SERVICE BULLETIN

DATE: 15 JUNE 1990
PAGE 1 OF 3

SUBJECT: ONE-TIME REPLACEMENT OF TAIL ROTOR BLADE PITCH ARM BOLT ATTACHING NUTS.

MODELS AFFECTED: All MD Helicopters, Inc. (MDHI) 369 Series helicopters, equipped with metal tail rotor blades.

Figure 1. Replacement of Tail Rotor Pitch Link Nuts.

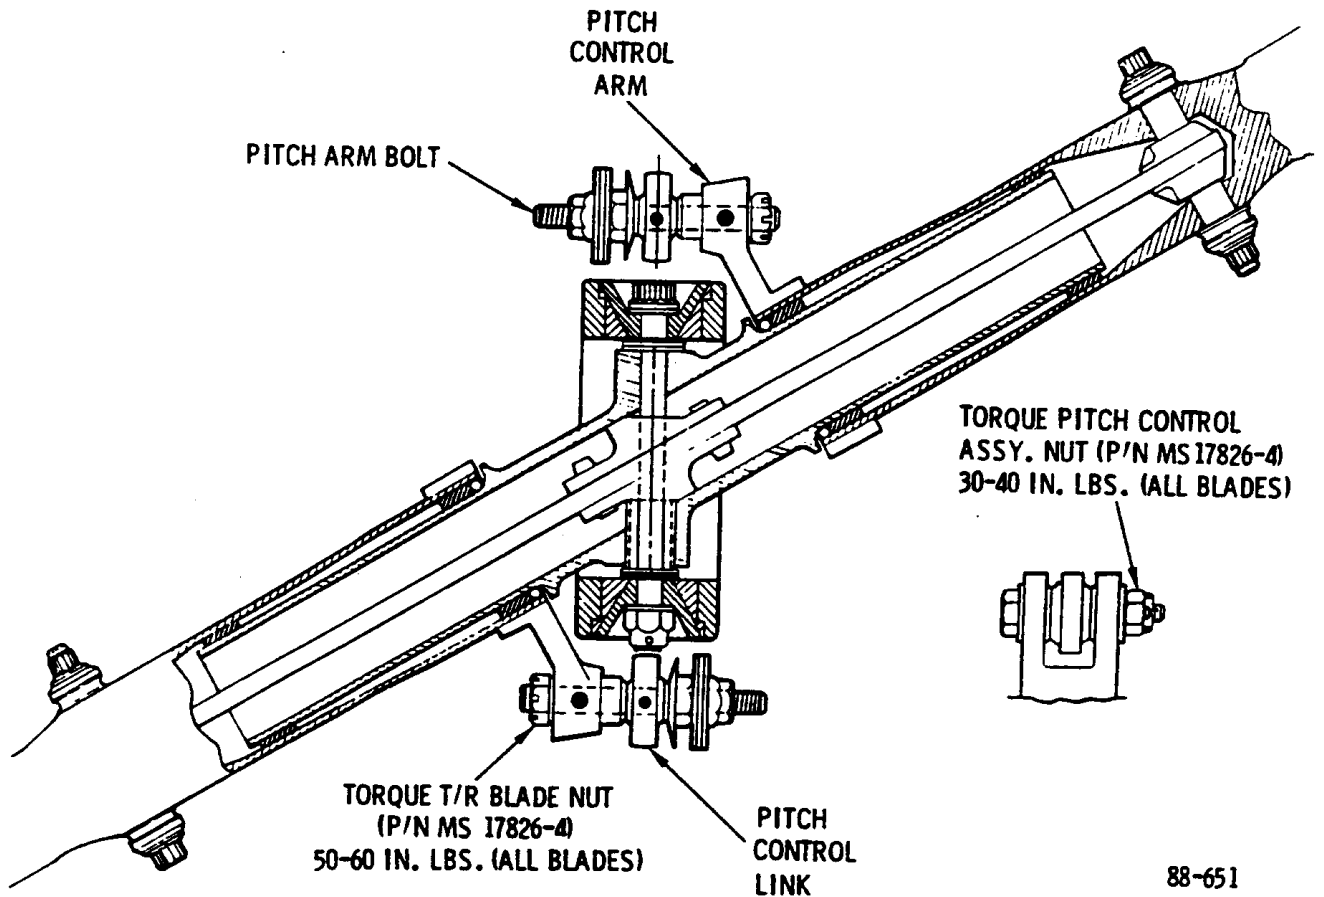
- a. Remove nuts at pitch control assembly and nuts at tail rotor blade pitch arm attachments. (Refer to Figure 1 .)
- b. Install new MS17826-4 nuts. Torque tail rotor blade nuts to **50 - 60 inch-pounds**. Torque nuts at pitch control assembly to **30 - 40 inch-pounds**.

DO NOT exceed 60 inch-pounds torque on the tail rotor blade nuts or 40 inch-pounds on the pitch control assembly nuts.

- c. Without exceeding torque limits, align cotter pin hole at the outboard and inboard ends of the pitch arm and install cotter pin.
